International
Aero Engines

SERVICE BULLETIN

NACELLE - EXHAUST - LEVER ASSEMBLY, THRUST REVERSER OUTER LOCKING
ACTUATOR - REPLACEMENT OF

V2500-NAC-78-0106

Thrust reverser outer locking actuator
Figure 1

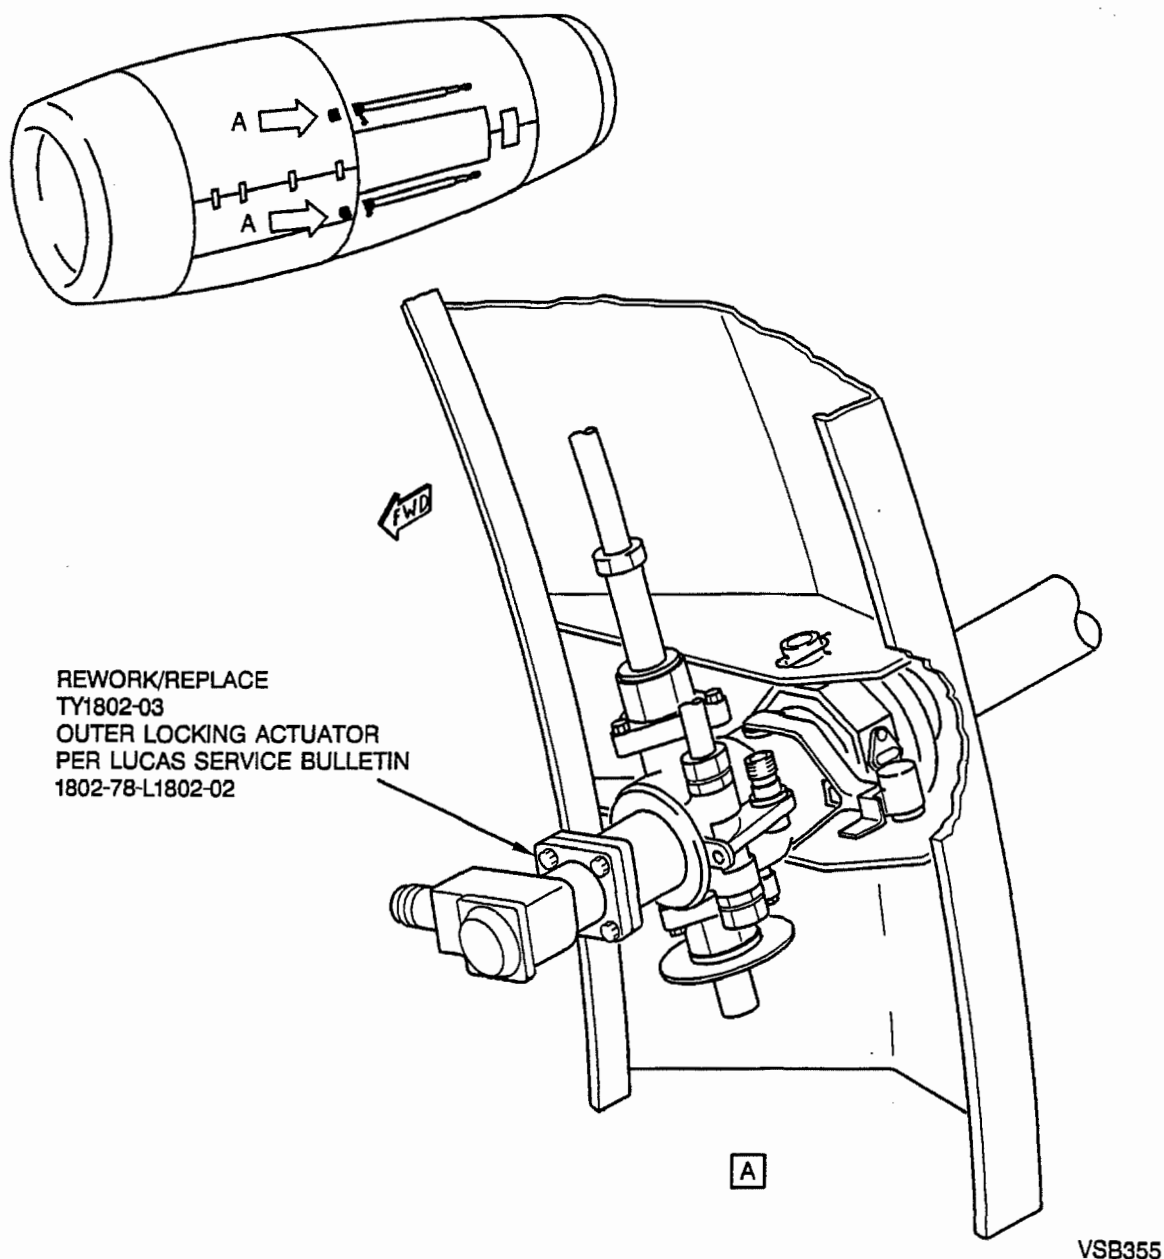
The change introduced by this Bulletin is to replace the existing thrust reverser outer locking actuator lever assembly with a redesigned lever assembly.

- (1) Locate TY1802-03 outer locking actuator on left hand upper and lower thrust reverser doors. Refer to Figure 1.
- (2) Visually examine stow pipe on TY1802-03 outer locking actuator for any damage. Refer to Lucas Aerospace Service Bulletin 1802-78-L1802-02 for possible damage area. If there is no damage, continue to paragraph 2.B.(3). If damage is visible, remove damaged outer locking actuator and install replacement TY1802-04 outer locking actuator. Refer to MD90 Aircraft Maintenance Manual, Chapter 78-31-14. Return damaged outer locking actuator to Lucas Aerospace and get replacement TY1802-04 outer locking actuator. Refer to Lucas Aerospace Service Bulletin 1802-78-L1802-02 for address and availability. Continue to paragraph 2.C.

- (3) Replace outer locking actuator lever assembly and proximity sensor, if required, and reidentify TY1802-03 outer locking actuator to TY1802-04 with instructions in Lucas Aerospace Service Bulletin 1802-78-L1802-02.

- (4) Make sure gap is correct between proximity sensor and outer locking actuator lever assembly. Refer to MD90 Aircraft Maintenance Manual, Chapter 78-33-11.

Replacement of Lever Assembly/Proximity Switch
Figure 1

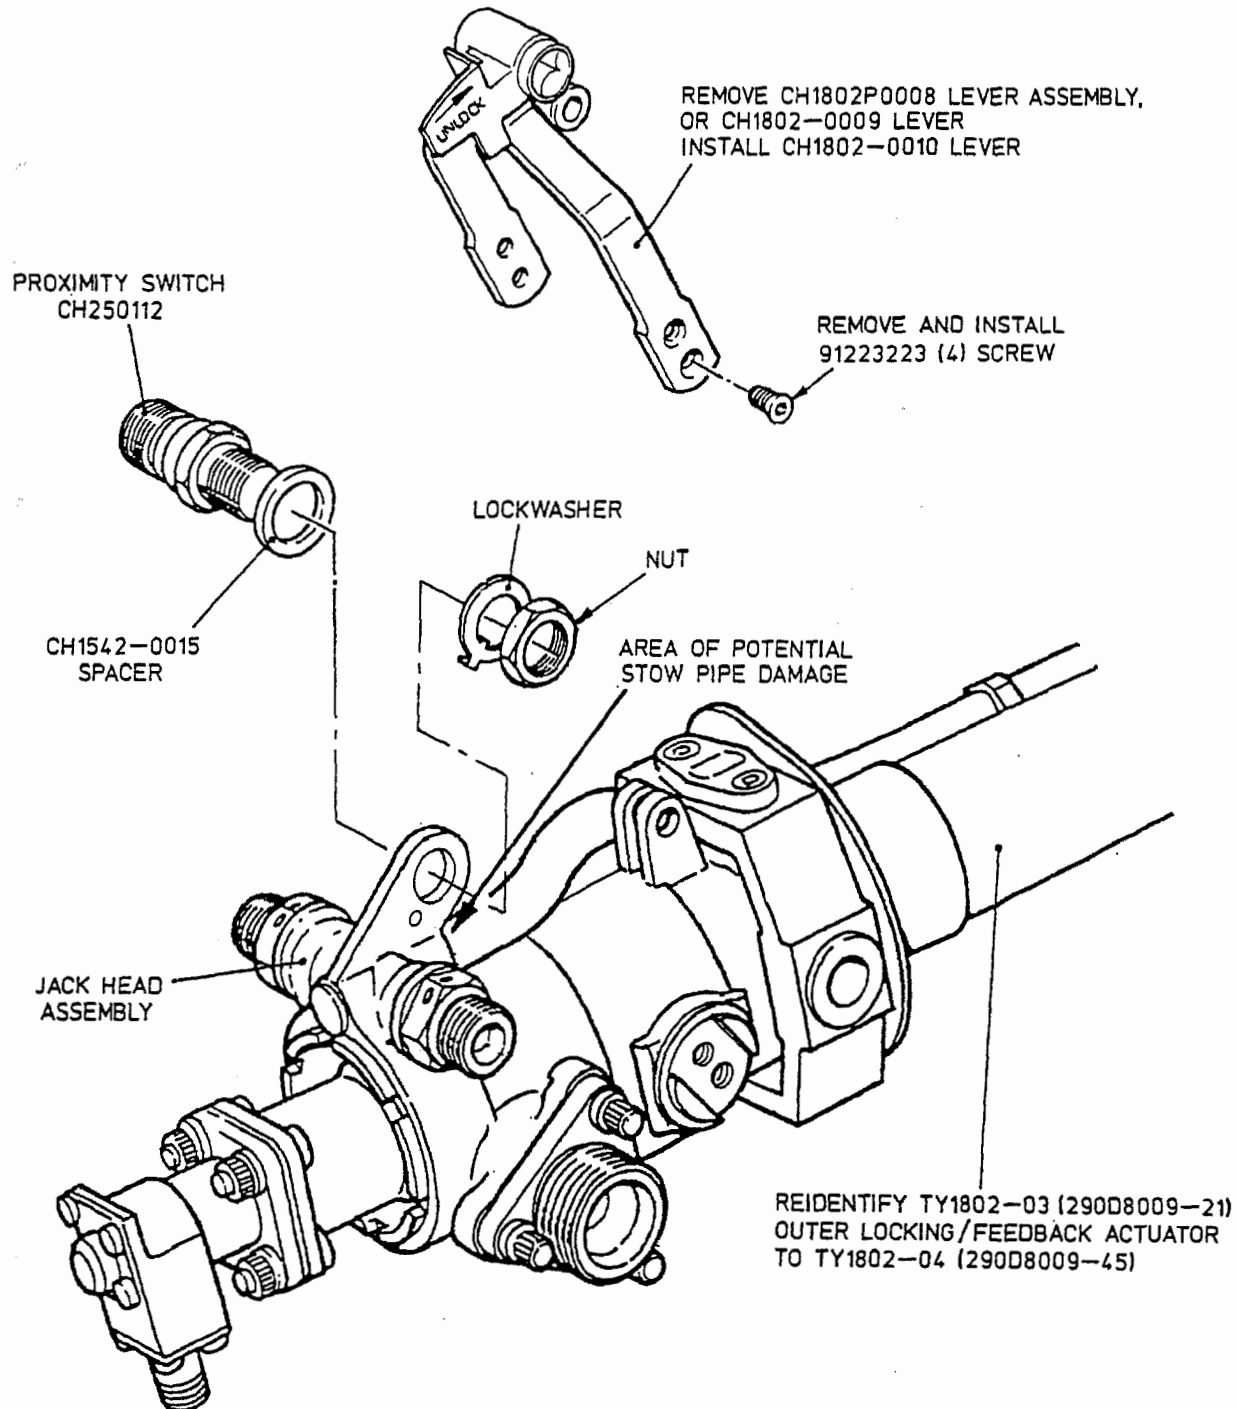
- A. Effectivity – MD90/V2500 Outer Locking/Feedback Actuator TY1802-03
- B. Reason – Operators have reported a foul condition between the lever assembly and proximity switch, resulting in damage to the proximity switch.

- C. Description – To introduce a modified lever preventing the foul condition with the proximity switch, and replace any damaged proximity switches. This Service Bulletin introduces build standard TY1802-04.

- (1) Visually examine the stow pipe attached to the jack head assembly. If there is any damage to the stow pipe (refer to Figure 1), remove the TY1802-03 outer locking/feedback actuator and return to Lucas Aerospace. Replace with TY1802-04 outer locking/feedback actuator and ignore the remainder of this service bulletin.

- (2) Remove the CH1802P0008 lever assembly (TY1802-03 letter A) or the CH1802-0009 lever (TY1802-03 letter B and C) from outer locking/feedback actuator with the four 91223223 screws (refer to Figure 1). Discard the CH1802P0008 lever assembly, return the CH1802-0009 lever to Lucas Aerospace. Retain screws.
- (3) Visually examine the CH250112 proximity switch for any damage which may have occurred from a foul with lever. If there is no damage, return proximity switch from kit to Lucas Aerospace and proceed to paragraph 2.B. (2). If damage has occurred, remove proximity switch as follows:
 - (a) Remove the wirelocking, remove the nut and lockwasher from CH250112 proximity switch. Retain nut and lockwasher.
 - (b) Remove CH1542-0015 spacer and CH250112 proximity switch. Discard proximity switch. Retain spacer.

- (1) If proximity switch required replacement, install new proximity switch as follows:
 - (a) Assemble the original CH1542-0015 spacer on new CH250112 proximity switch.
 - (b) Put CH250112 proximity switch on jack head assembly of outer locking/feedback actuator with lockwasher and nut. Tighten nut to a torque of 12 to 16lbf ft (16,3 to 21,7Nm).
- (2) Apply Hylomar SQ32M or PL32M jointing compound to four 91223223 screws. Put new CH1802-0010 lever on outer locking/feedback actuator with four 91223223 screws. Tighten the screws to a torque of 2.35 to 2.75lbf ft (3,15 to 3,85Nm).

- (3) Using Setting Slip CH1542-0203 or other suitable means, make sure the clearance between the CH250112 proximity switch and the CH1802-0010 lever target face is 0.059 to 0.079 in (1,5 to 2,0 mm). If necessary to obtain the correct clearance select and install a spacer of the correct thickness from the graded range CH1542-0015-1, CH1542-0015-2, CH1542-0015-3 supplied with the mod kit. It may be necessary to use a number of spacers.
- (4) With locking wire, lock the proximity switch nut to the proximity switch.
- (5) Re-identify outer locking/feedback actuator with the vibro-peen method. Refer to paragraph 2.C.
